July 24, 1998

**RE: YOUTH DEVELOPMENT INC. MODULAR BUILDING SITE (K20-D36).
GRADING & DRAINAGE PLAN FOR BUILDING PERMIT APPROVAL.
ENGINEER'S STAMP DATED JUNE 29, 1998.**

RE: DRAINAGE PLAN FOR CHICO CHILD DEVELOPMENT CENTER (K20-D36)
ENGINEER'S STAMP DATED 4/11/97

RE: DRAINAGE PLAN FOR A SITE AT GENERAL BRADLEY NE (K20-D36)
ENGINEER'S STAMP DATED 1/17/94.

Sheet Title:
GRADING AND
DRAINAGE
PLAN

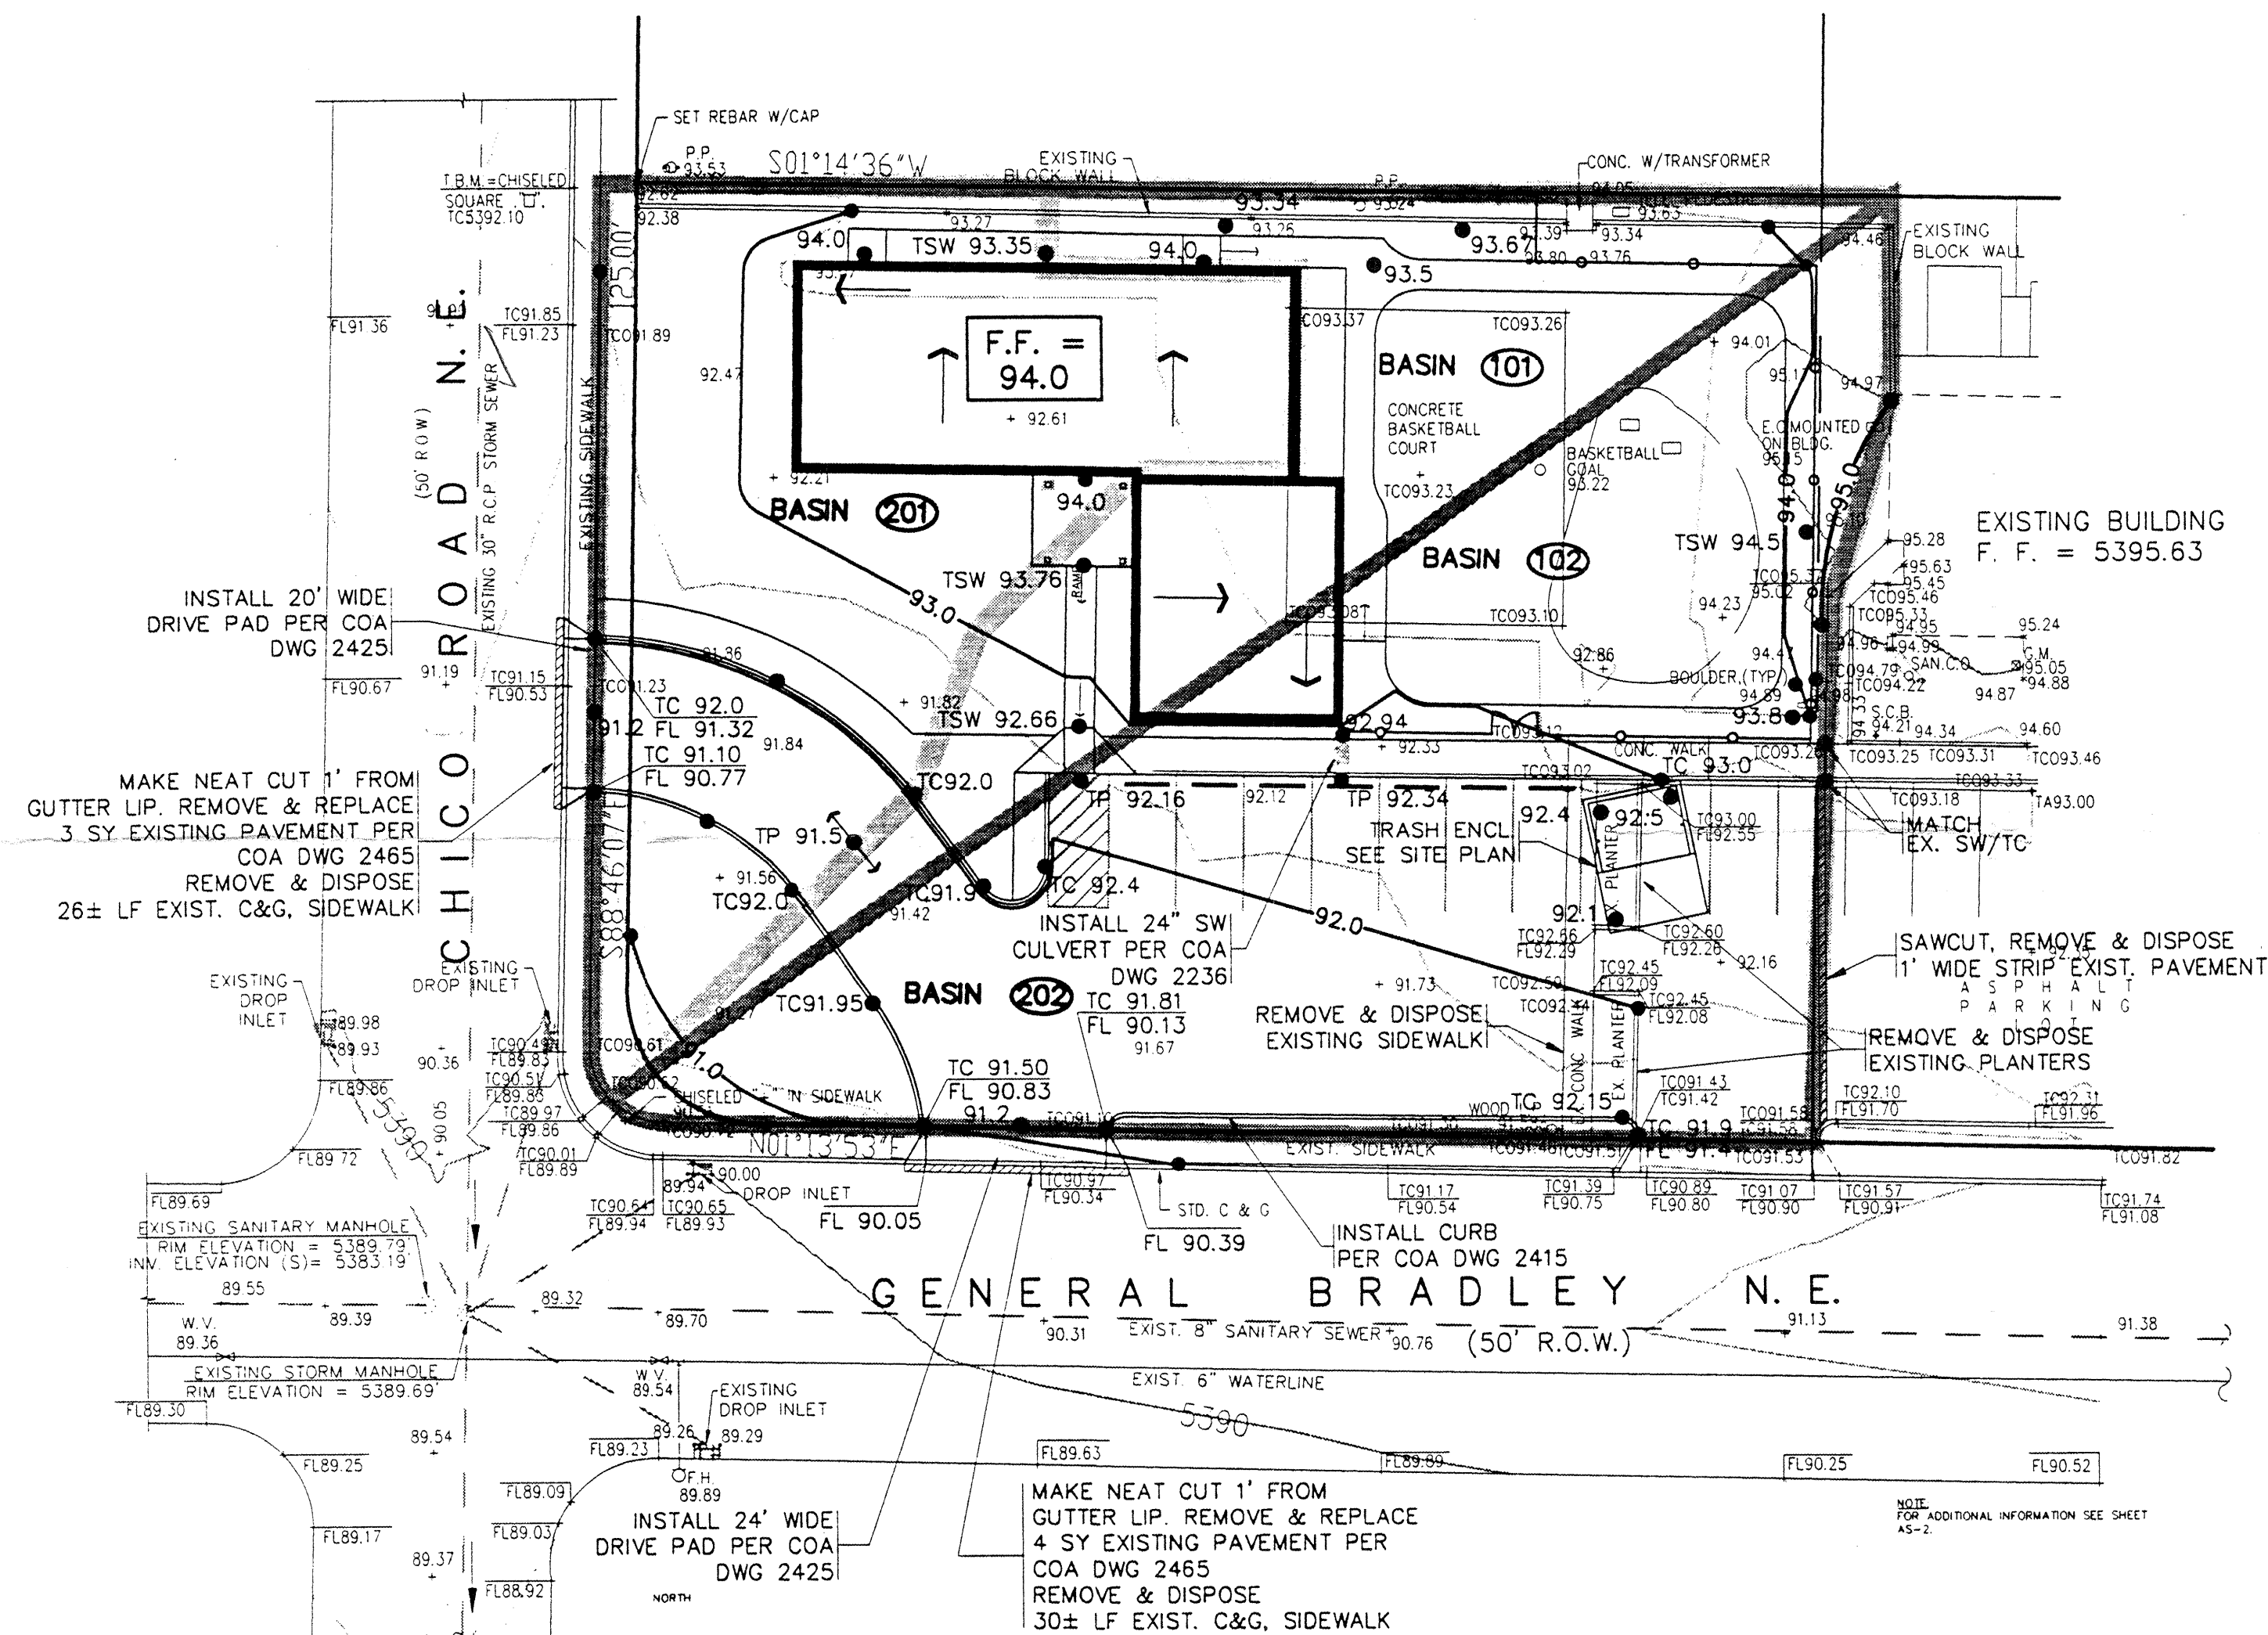
As I discussed with Ms. Susco today, please note on the plan that Basins 101 / 201 and 102 / 202 are essentially the same. Also, highlight General Bradley on Location Map.
